Regional Municipality of Durham

Bid Opportunity: T-1032-2021 – Relocation of Oral Health Clinic to 200 John Street, Oshawa

Addendum Number 01 - April 29, 2021

SCHEDULES

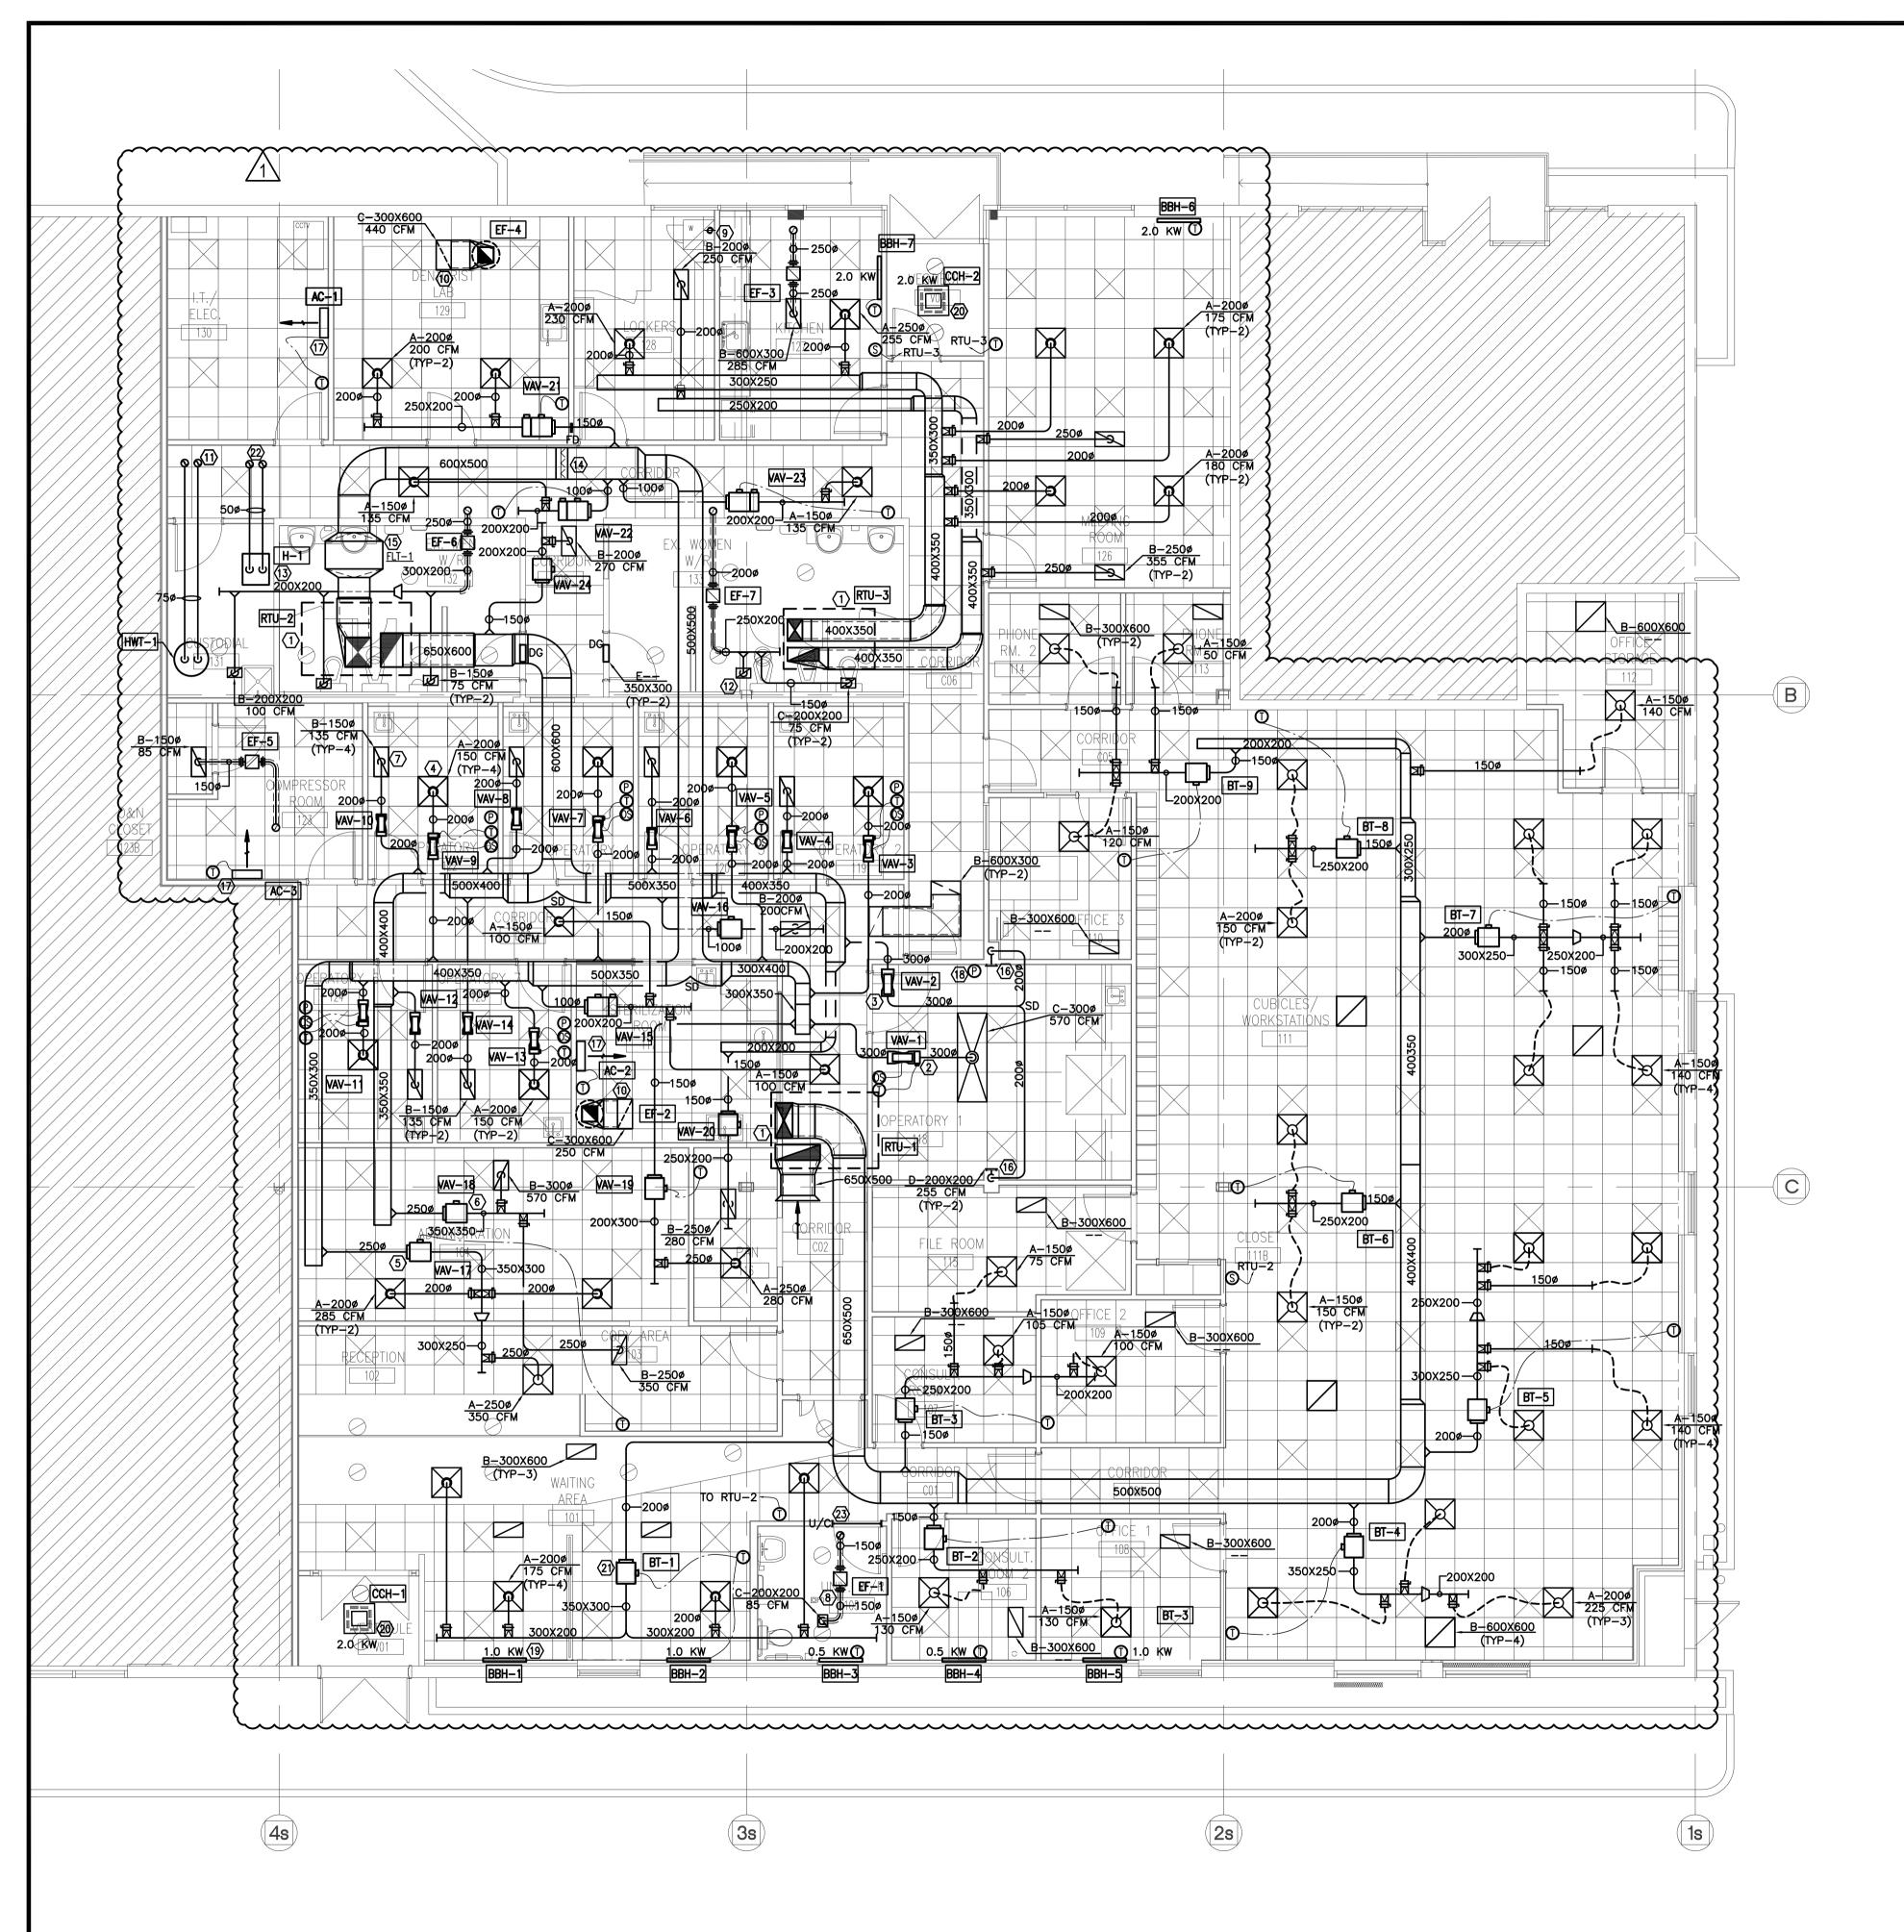
Refer to details 1-3/A-014.
 - .2 Noted locations and quantity of speak-thru's required. Refer to details 2&3/A-014.
 - .3 Extra reception chair included.
- .5 Drawing A-017 Schedules has been modified as part of this addendum.
 - .1 See clouded revisions on door schedule to reflect questions throughout Addendum 01.
 - .2 Ceiling heights have been adjusted.

Door finish should be urethane, not paint. Refer to revised Drawing A-017, attached to this Addendum.

RELOCATION OF DENTAL CLINIC TO 200 JOHN ST., OSHAWA GROUND FLOOR PLAN -HVAC SHEET METAL

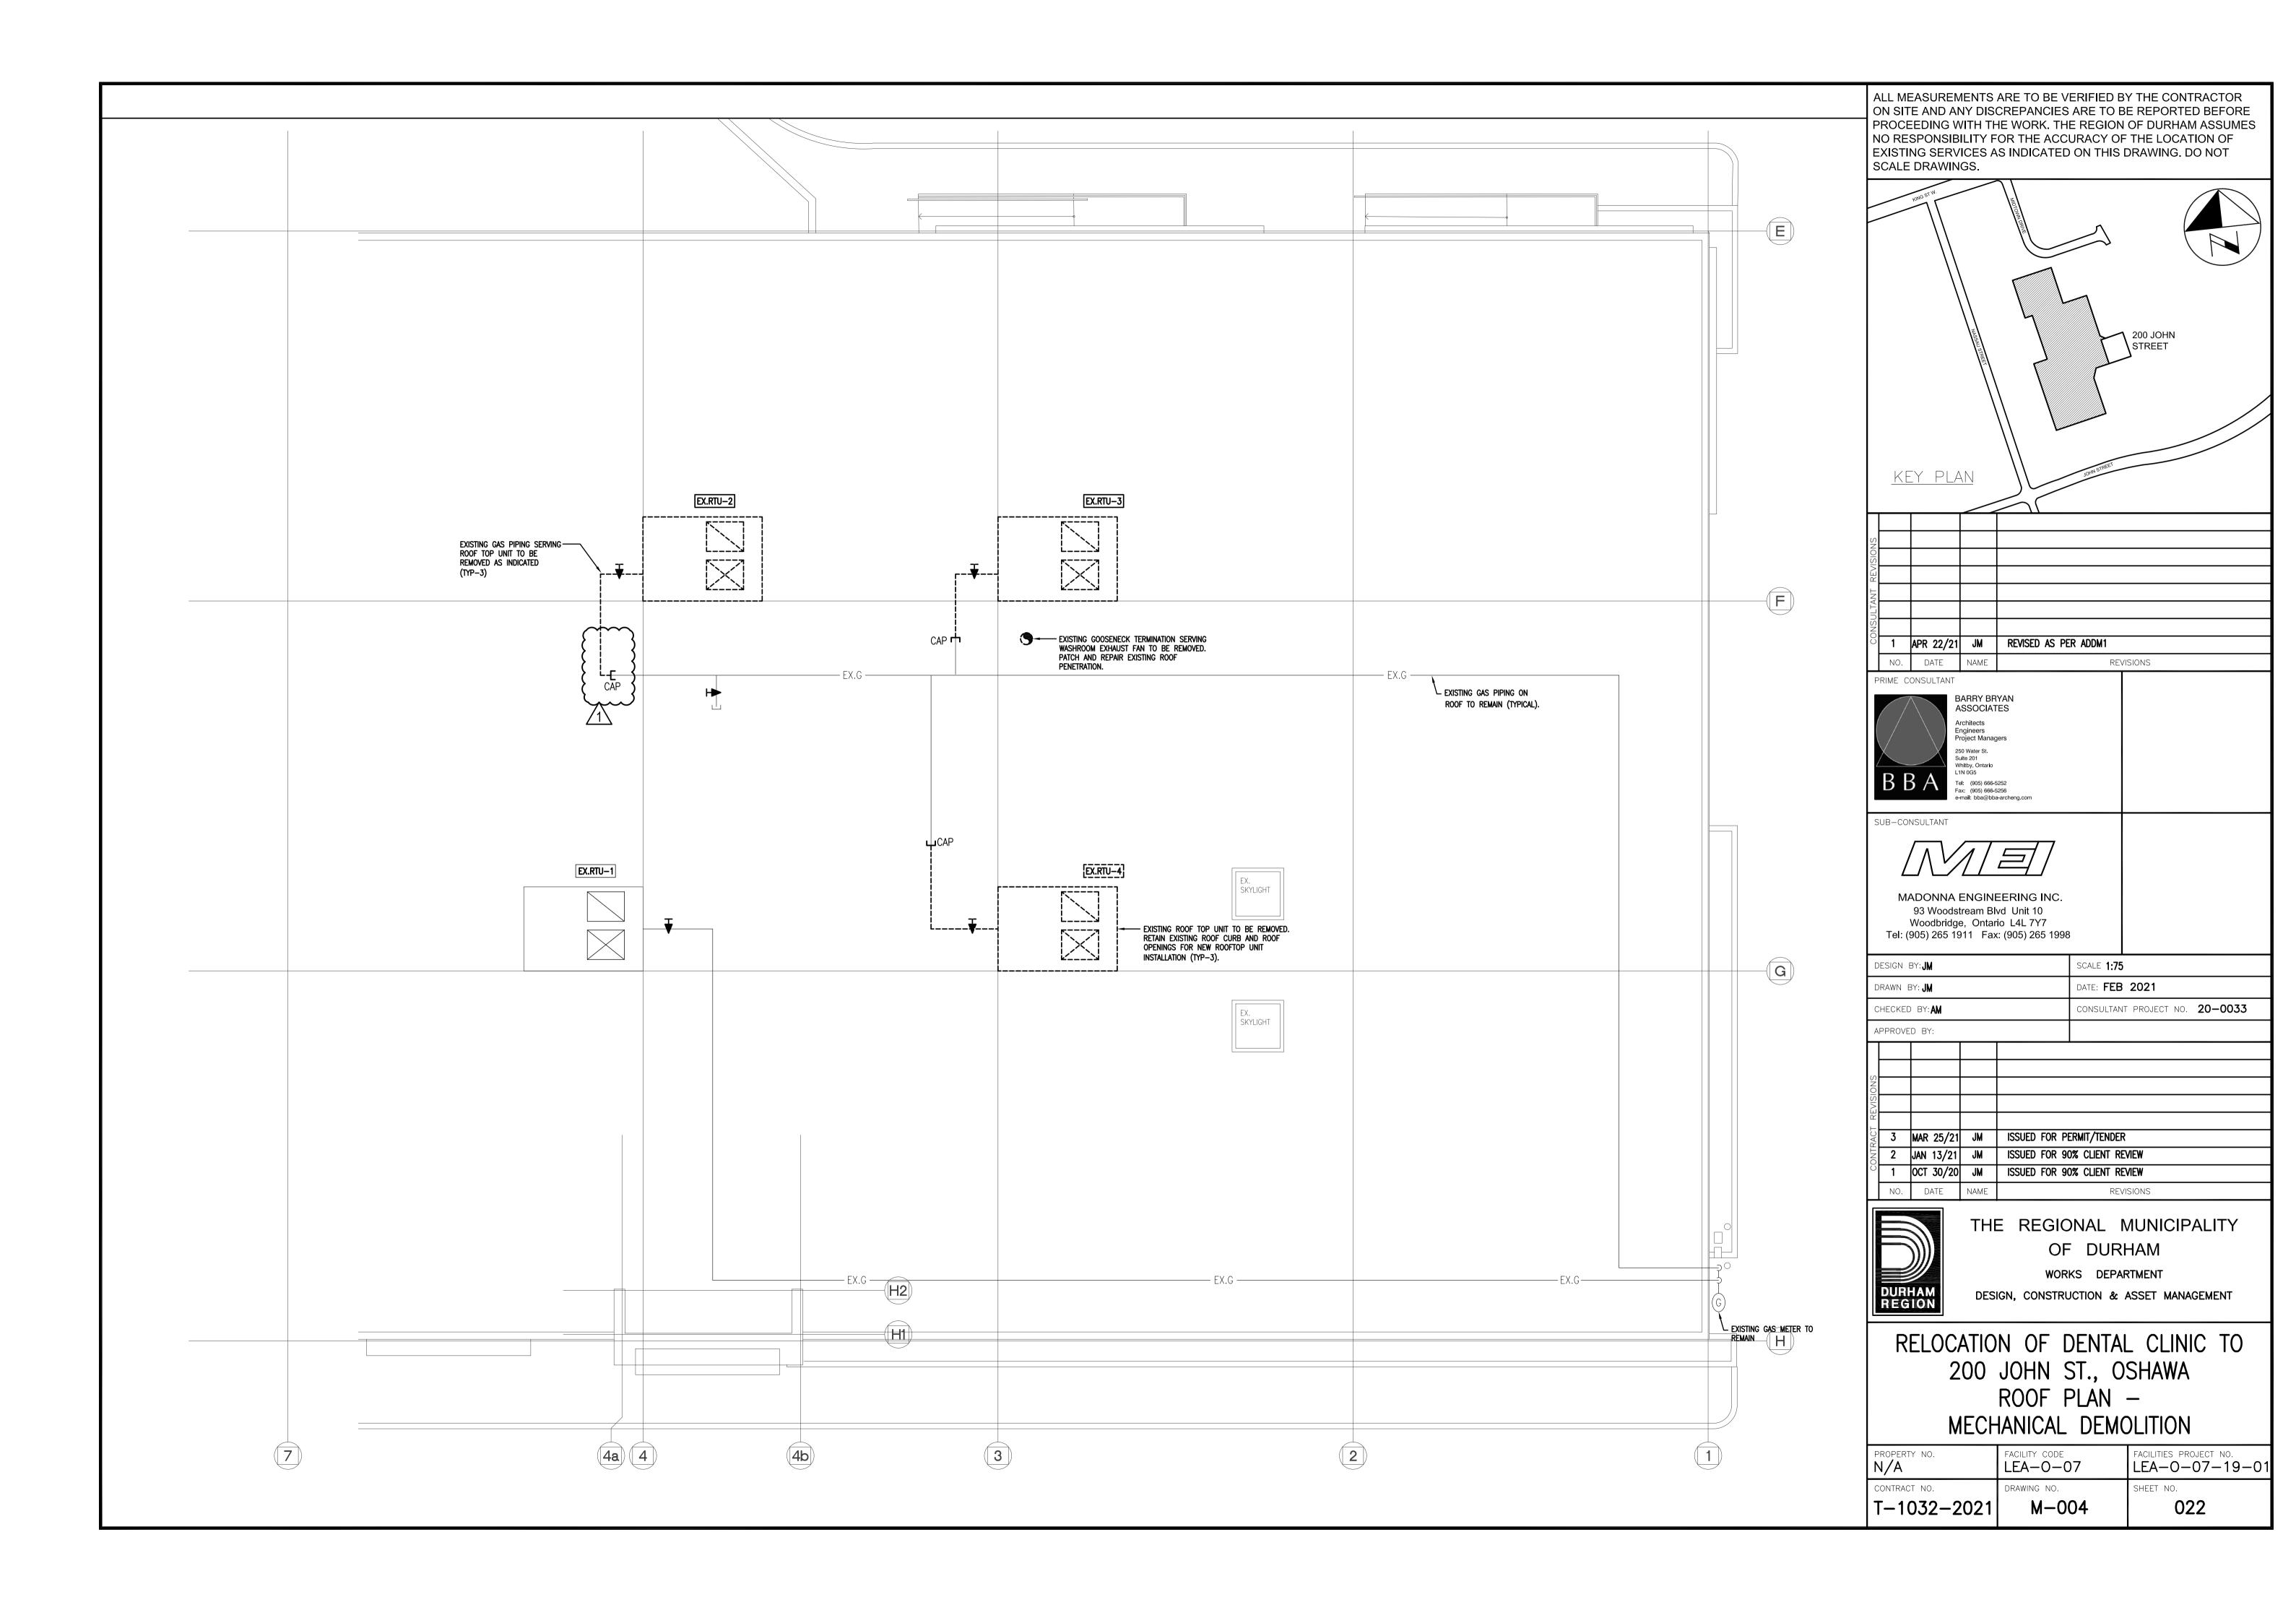
- .1 Drawing M-002 Ground Floor Plan HVAC Sheet Metal has been modified as part of this addendum:
 - .1 Ductwork routing for RTU-1, 2 & 3 revised as shown.
 - .2 Revised location, number, quantities and duct sizes of VAV's as shown.
 - .3 Revised location, number, quantities and duct sizes of Bypass terminals as shown.
 - .4 Revised quantity, location and capacities of baseboard heaters as shown.
 - .5 Revised exhaust airflow volumes for EF-3 & EF-4.
 - .6 Revised supply airflow volume for VAVs and BTs as shown on drawing.
 - .7 Relocated FLT-2 where shown. Reassigned FLT-2 to FLT-1.Deleted original FLT-1 from drawing.
 - .8 Deleted transfer ducts from drawing.
 - .9 Added temperature sensors for constant volume RTUs where shown.
 - .10 Revised location and duct routing of EF6 and EF-7
 - .11 Drawing notes 13, 15 and 21 revised as shown.
